SERVICE BULLETIN No. C8E38-75-002

ENGINE AIR - COMPRESSOR CONTROL - BLEED VALVE CONTROL

BLEED VALVE CONTROL UNIT

INTRODUCTION OF BVCU TYPE NUMBER C8E38-14

-9 BVCU Conversion - Motherboard Links
Figure 1

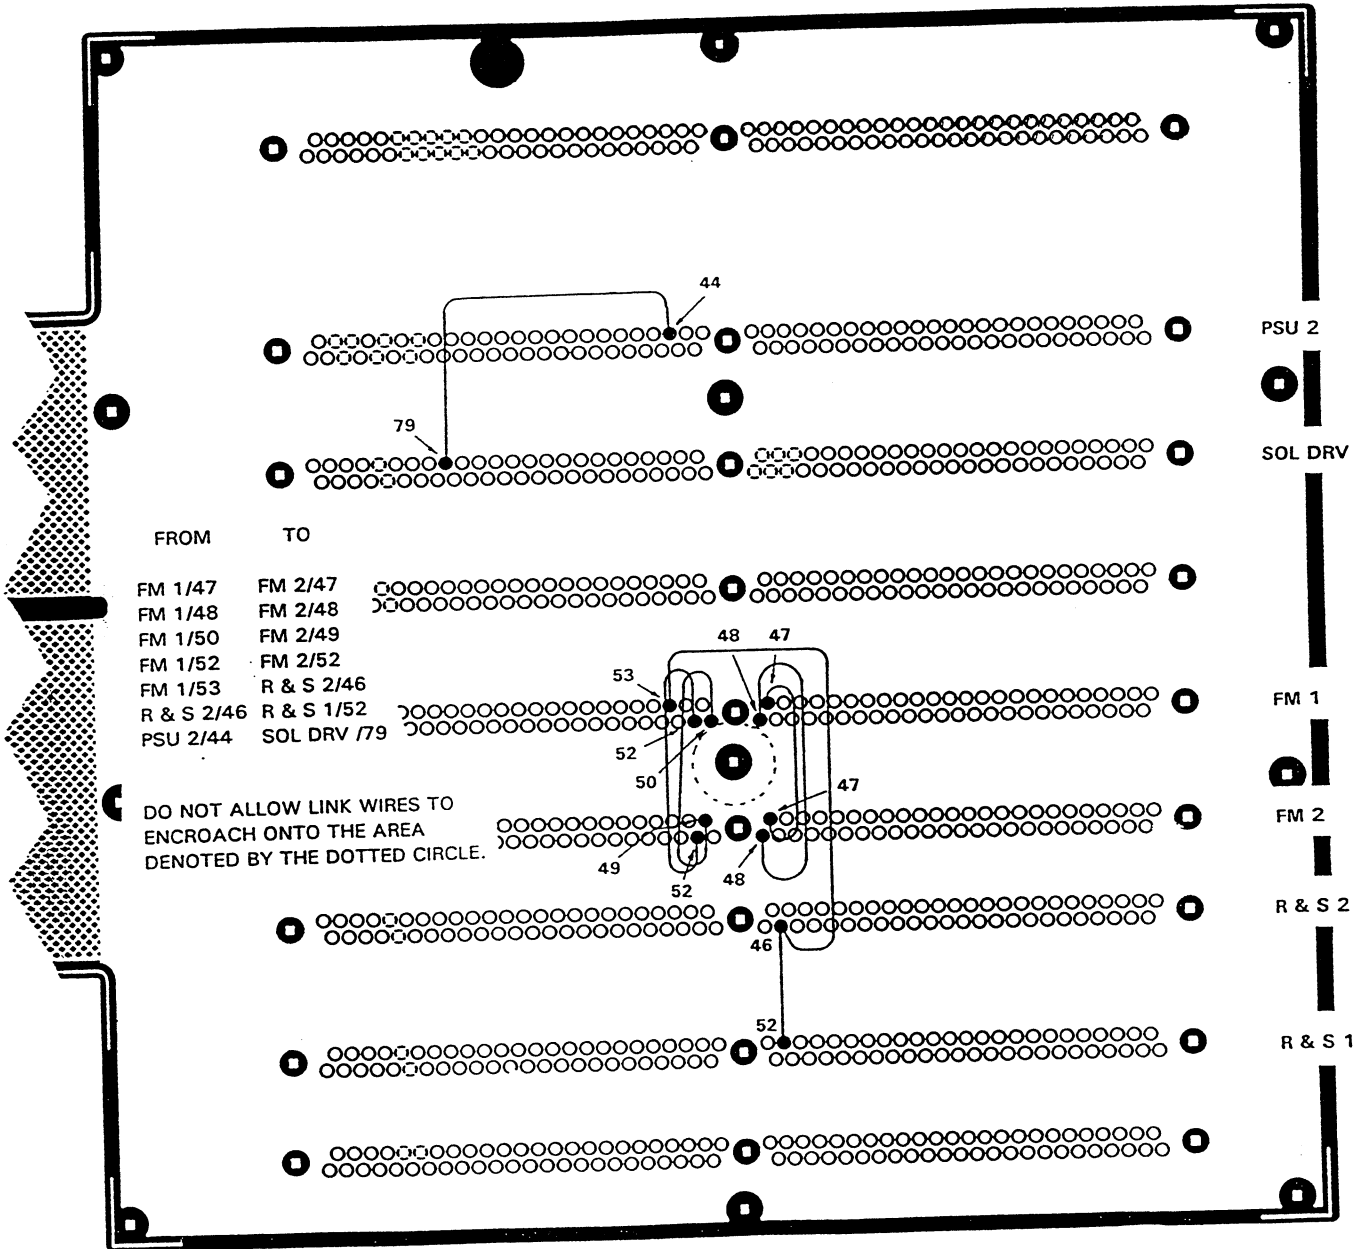
- (1) Refer to Fig. 1 in this Service Bulletin. On the motherboard, locate and identify the pin connections listed in the table in Fig. 1.
 - (2) Refer to CMM 75-32-02, Repair page 601 and up, and familiarise yourself with the procedures for soldering work on conformally coated boards.

- (3) After removing the conformal coating locally around each pin connection, make up a set of links using Raychem Type 44, 7/0.0063 wire, Part No. 44A702926 (or its equivalent). Form the stripped ends of each link into tinned hooks of a size to fit over the protruding connector pins.

- (4) Solder the links to the connector pins, ensuring that a good fillet of solder is formed around each hook.
 - (5) Using Dow Corning adhesive RTV 3145 (or its equivalent), tack each link to the motherboard surface at frequent intervals.

Modification of R & S 2 PCB
Figure 2

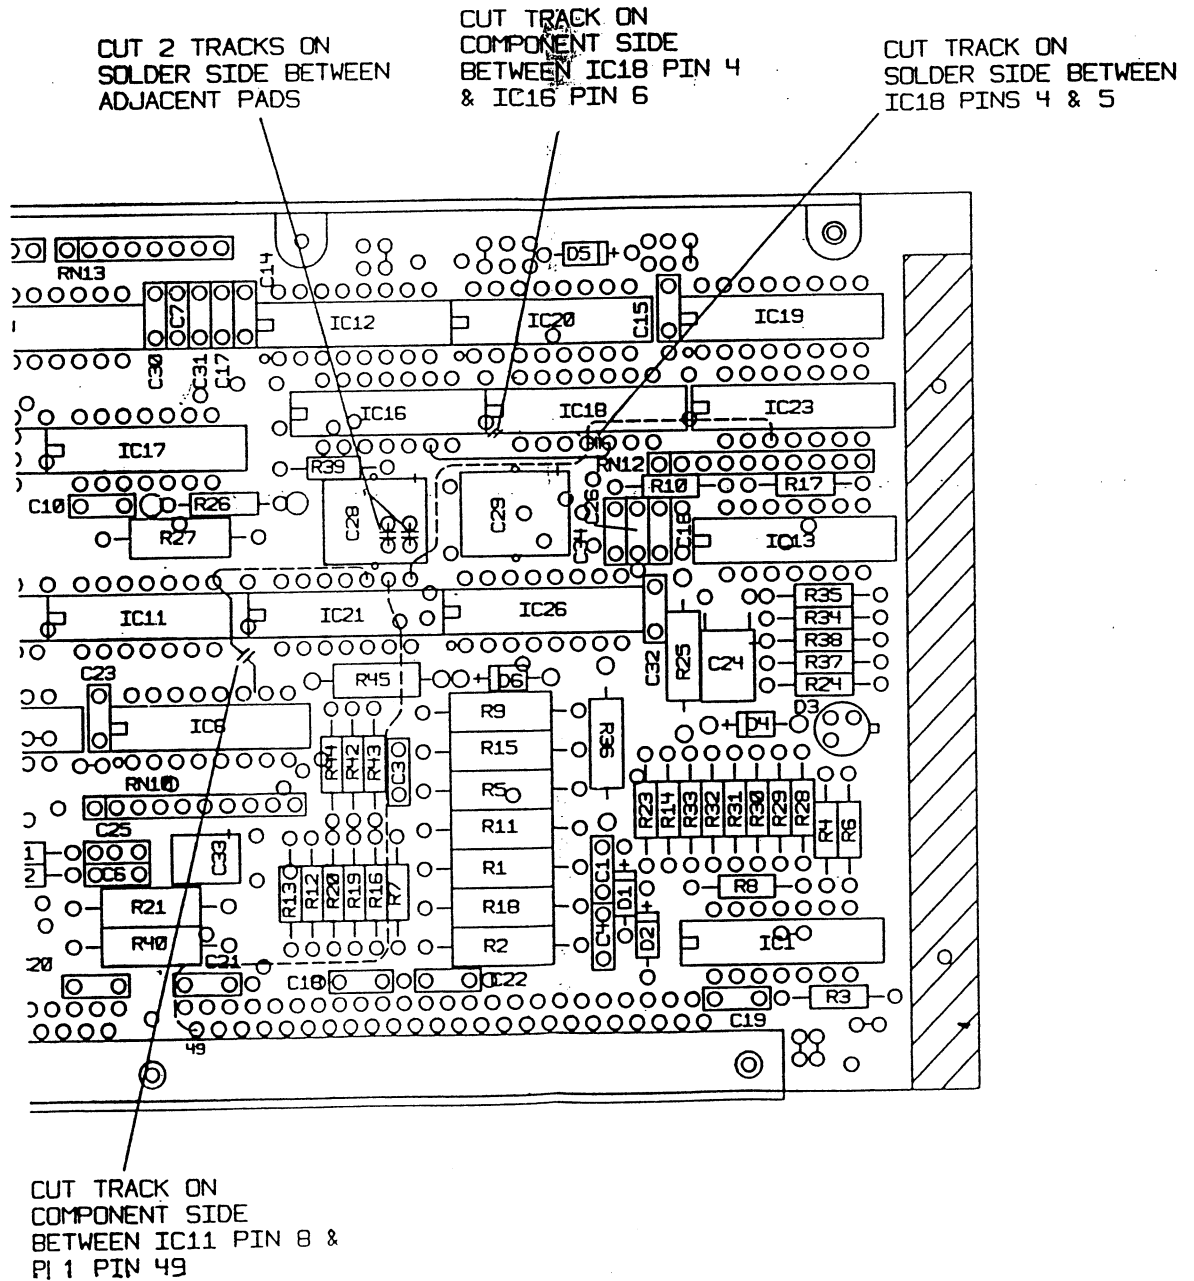
B. Modify the R & S 2 PCB (see Fig. 2)

- (1) Refer to CMM 75-32-02, Repair, page 601 and familiarise yourself with the procedures for soldering work on conformally coated PCBs.
- (2) Refer to IPL Fig. 7B in CMM 75-32-02: locate and identify IC10 and IC24.
- (3) From the Mod. Kit, obtain the new programmed ICs 10 and 24.
- (4) Remove the conformal coating around the existing ICs 10 and 24.
- (5) Use a solder sucker to remove all solder from the plated-through holes for ICs 10 and 24.
- (6) Remove and discard the existing ICs 10 and 24.
- (7) Crop the leads of the new ICs 10 and 24 and fit them. Solder in place.

- (8) Refer to Fig. 2 and identify the five places on the PCB where tracks have to be cut.
- (9) Using an approved tool, cut the tracks in the five places you have identified. Ensure that you remove all swarf.
- (10) Refer to Fig. 2 and identify the five links which are to be added. These are all on the solder side of the PCB and are :

FROM	TO
IC11, pin 8	IC21, pin 10
IC21, pin 9	PL1, pin 49
IC21, pin 8	IC18, pin 4
IC18, pin 4	IC23, pin 3
IC18, pin 5	IC16, pin 6

- (11) Remove the conformal coating locally around each of the 10 points listed above.
- (12) Using wire from the Mod.Kit, cut the links to size and form them as shown in Fig. 2. Note that the links must not cross over solder pads on the PCB.
- (13) Solder the links in place.
- (14) Using Dow Corning adhesive RTV3145 (or its equivalent), tack each link to the PCB at about 25mm intervals.
- (15) Remove and discard the original PCB labels and fit new labels from the Mod. Kit. Endorse the S/N label with the original serial number of the PCB. Endorse the Pt. No. label with the new part number, 016-CE-00-0020.
- (16) Repair the conformal coating as detailed in CMM 75-32-02, Repair, page 605. Add a layer of conformal coating over the new labels.
- (17) Store the modified R & S 2 PCB in an anti-static bag until you are ready to install it into the BVCU.

Modification of FM 2 PCB, Pt. No. 012-CE-00-0010

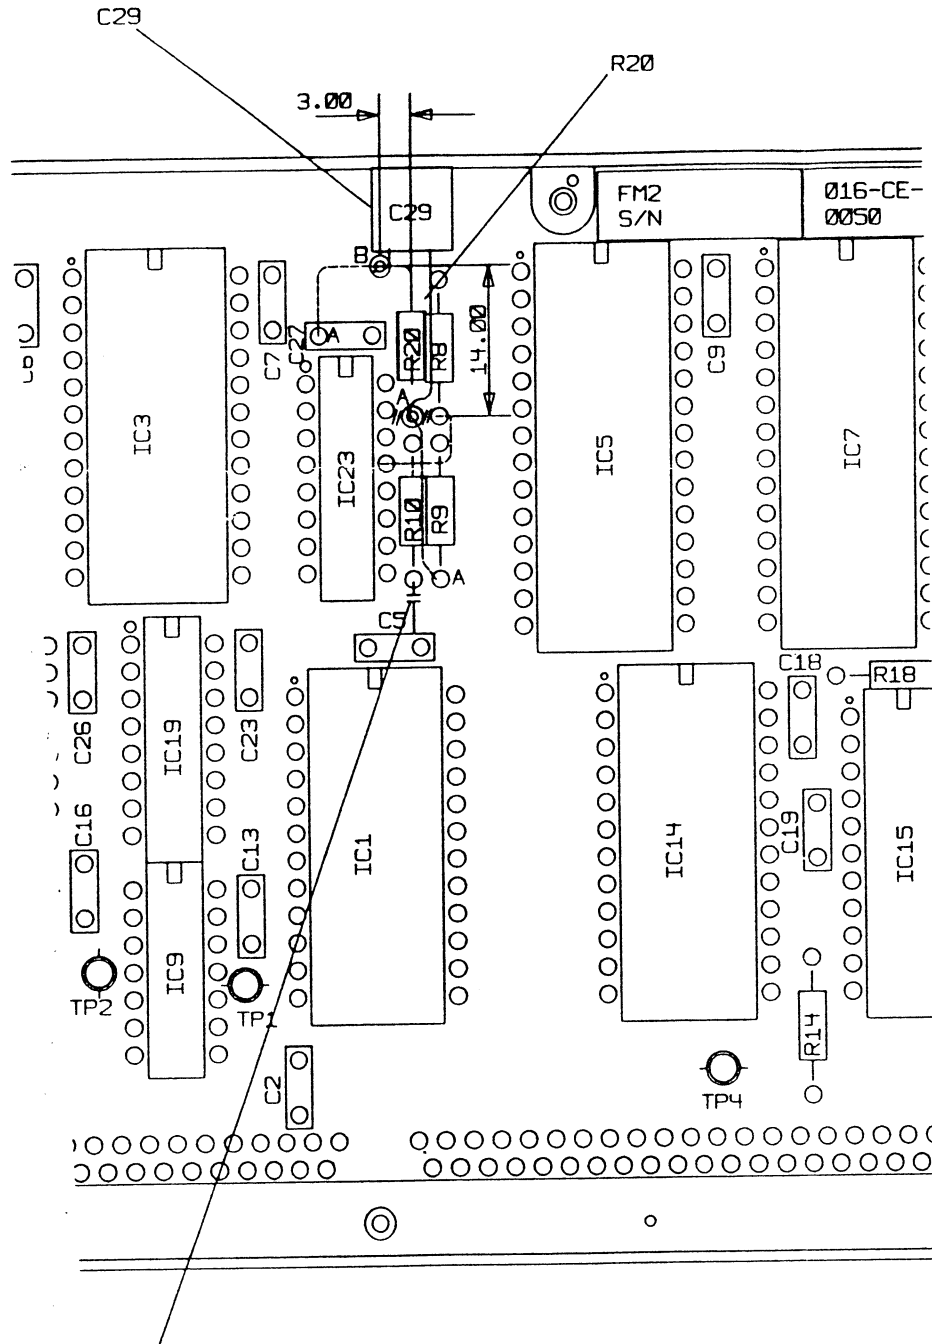
- (3) Erase the program and re-program, using the latest issue of PL Document 016-CE-00-0057.
- (4) Refer to Fig. 3A and identify the three places where the PCB tracking is to be cut.

- (5) Using an approved tool, cut the tracking in one position to isolate the R10 pad. Ensure that you remove all traces of swarf.
- (6) Cut the tracking in a further two positions to isolate the R12 pad. Ensure that you remove all traces of swarf.

- (7) Remove the conformal coating locally, as required, in the work areas.
- (8) Obtain the pin, Pt. No. K3334-753-0-8, from the Mod. Kit and fit it in position 'A' (Fig. 3A).

- (9) Drill a 1.98mm (± 0.05 mm) diameter hole in position 'B' (Fig. 3A). Remove all traces of swarf.
- (10) Obtain the pin, Pt. No. 23352-656-0-8, from the Mod. Kit and fit it in position 'B'.

- (11) Obtain capacitor C29 and resistor R20 from the Mod. Kit.
- (12) Fit C29 and R20 as shown in Fig. 3A. C29 must be bonded to the PCB using Dow Corning adhesive RVT3145 (or its equivalent). In addition, the lead of C29 which is soldered to pin 'A' must be sleeved using sleeving from the Mod. Kit.

- (13) Refer to Fig. 3A and identify the three links which are to be fitted. These are all on the solder side of the PCB and are :

FROM	TO
C29/R20 (pin 'A')	R9A
C29/R20 (pin 'B')	C27A
IC23, pin 13	R8

- (14) Using wire from the Mod. Kit, cut the links to size and form them as shown in Fig. 3A. Note that the links must not cross over solder pads on the PCB.

Modification of FM 2 PCB, Pt. No. 007-CE-00-0050
Figure 3B

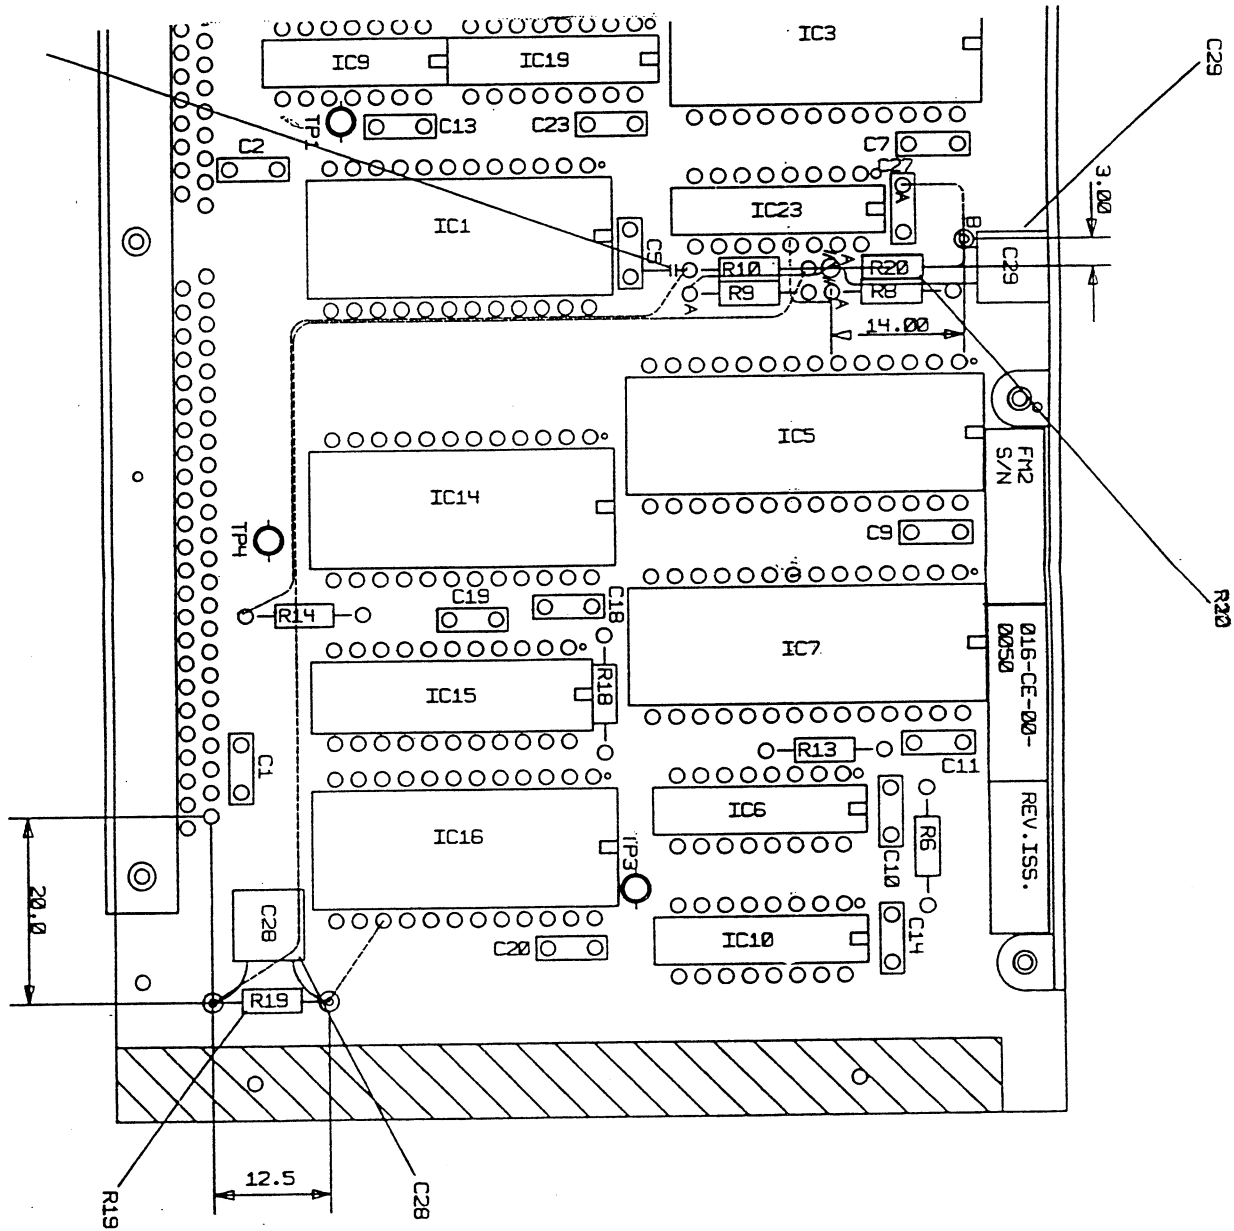
- (22) Erase the program and re-program, using the latest issue of PL Document 016-CE-00-0057.
- (23) Refer to Fig. 3B and identify the place where the PCB tracking is to be cut.

- (24) Using an approved tool, cut the tracking in one position to isolate the R10 pad. Ensure that you remove all traces of swarf.

- (25) Remove the conformal coating locally, as required, in the work areas.
- (26) Drill four 1.98mm (± 0.05 mm) diameter holes in the positions shown in Fig. 3B. Remove all traces of swarf.
- (27) Obtain three pins Pt. No. 23352-656-0-8, and one pin Pt. No. K3334-753-0-8 from the Mod. Kit and fit as follows :

Pins Pt. No. 23352-656-0-8 in positions C29B, R19A and R19B.
 Pin Pt. No. K3334-753-0-8 in position R20A.

- (28) Obtain capacitor C29 and resistor R20 from the Mod. Kit.
- (29) Fit C29 and R20 as shown in Fig. 3B. C29 must be bonded to the PCB using Dow Corning adhesive RVT3145 (or its equivalent). In addition, the lead of C29 which is soldered to pin 'A' must be sleeved using sleeving from the Mod. Kit.
- (30) Refer to Fig. 3B and identify the six links which are to be fitted. These are all on the solder side of the PCB and are :

FROM	TO
C29/R20 (pin 'A')	R9A
C29/R20 (pin 'B')	C27A
IC23, pin 13	R8

FROM	TO
R10 (pin 'A')	R14A
R10 (pin 'B')	R19B
R19A	IC16, pin 15

- (31) Using wire from the Mod. Kit, cut the links to size and form them as shown in Fig. 3B. Note that the links must not cross over solder pads on the PCB.
- (32) Solder the links in place.
- (33) Using Dow Corning adhesive RTV3145 (or its equivalent), tack each link to the surface of the PCB at about 25mm intervals.
- (34) Remove and discard the original PCB labels and fit new labels from the Mod. Kit. Endorse the S/N label with the original PCB serial number. Endorse the Pt. No. label with the new part number, 016-CE-00-0050.
- (35) Repair the conformal coating as detailed in CMM 75-32-02, Repair, page 605. Add a layer of conformal coating over the new labels.

Modification of Motherboard and Flexi-Rigid Assembly
Figure 4

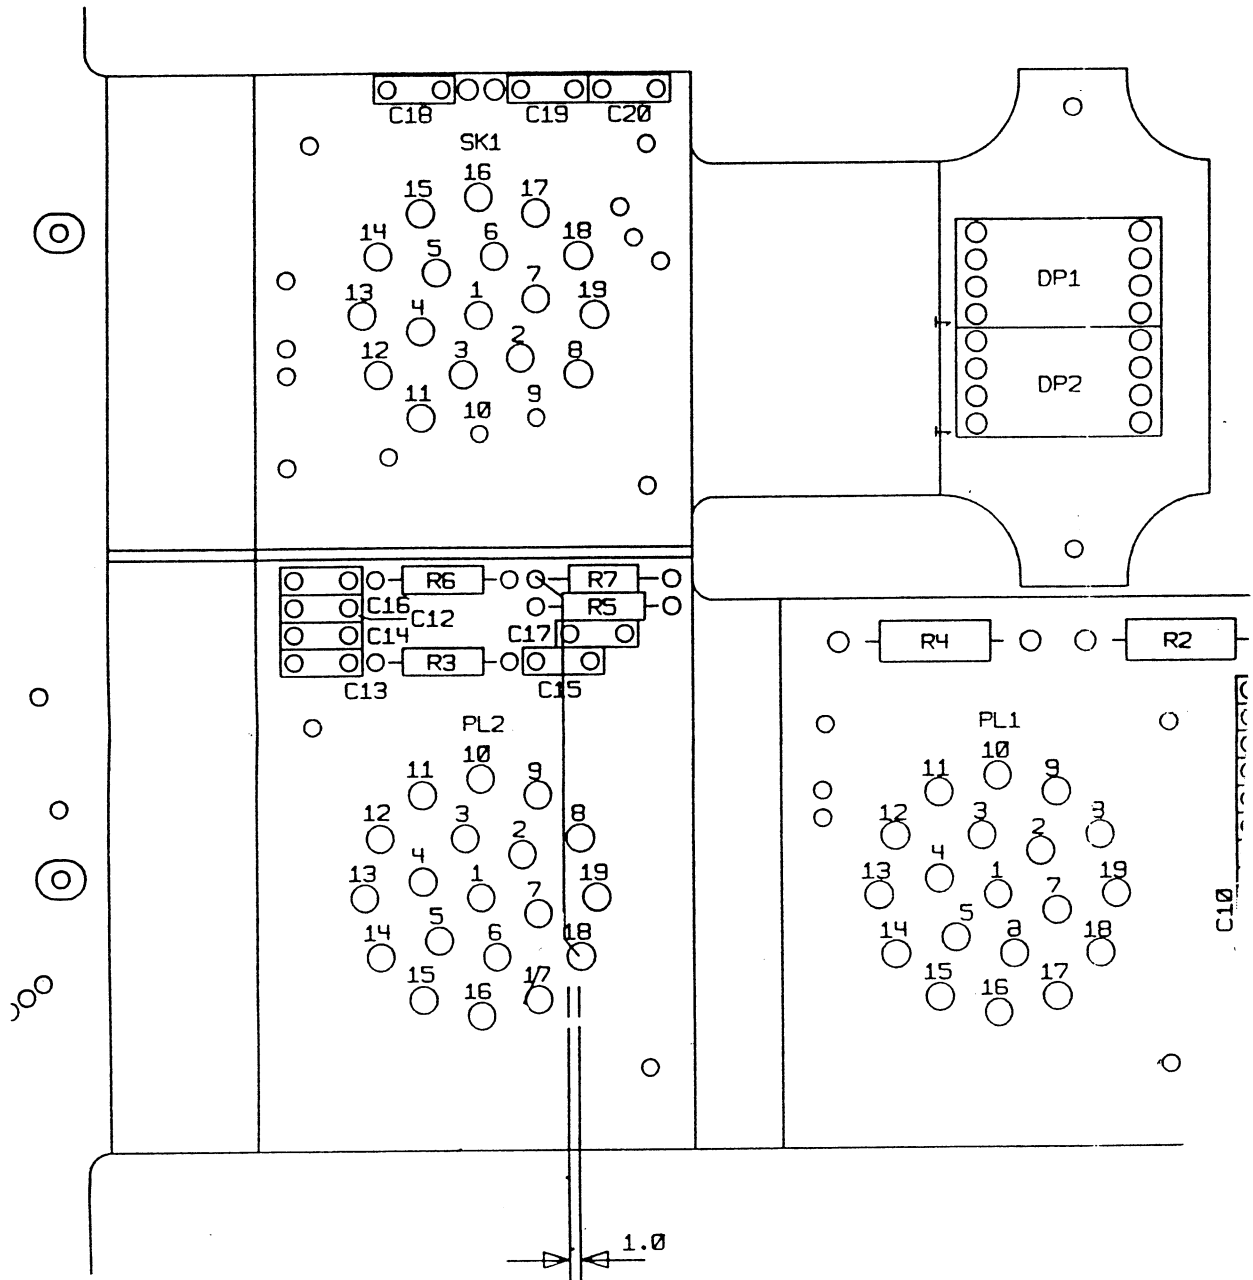
D. Modify the Motherboard and Flexi-Rigid Assembly (Fig. 4)

- (1) Refer to CMM 75-32-02, Repair, page 601, and familiarise yourself with the procedures for soldering work on conformally coated PCBs.
- (2) Refer to Fig. 4 and locate resistor R7 and pins 17 and 18 of PL2.

- (5) Remove the conformal coating locally as required in the work areas.
- (6) Using an approved tool, cut the PCB tracking between R7 and pin 17 of PL2, in the position shown in Fig. 4. Ensure that all traces of swarf are removed.

- (7) Using a continuity tester, check that an open circuit exists between R7 and pin 17 of PL2.
- (8) Obtain the link wire from the Mod.Kit. Trim and form it as shown in Fig. 4, so as to link R7 to pin 18 of PL2.

- (9) Solder the link between R7 and pin 18 of PL2 and tack the link to the rigid board using Dow Corning adhesive RTV3145 (or its equivalent). Ensure that the adhesive is not applied on top of component pads.
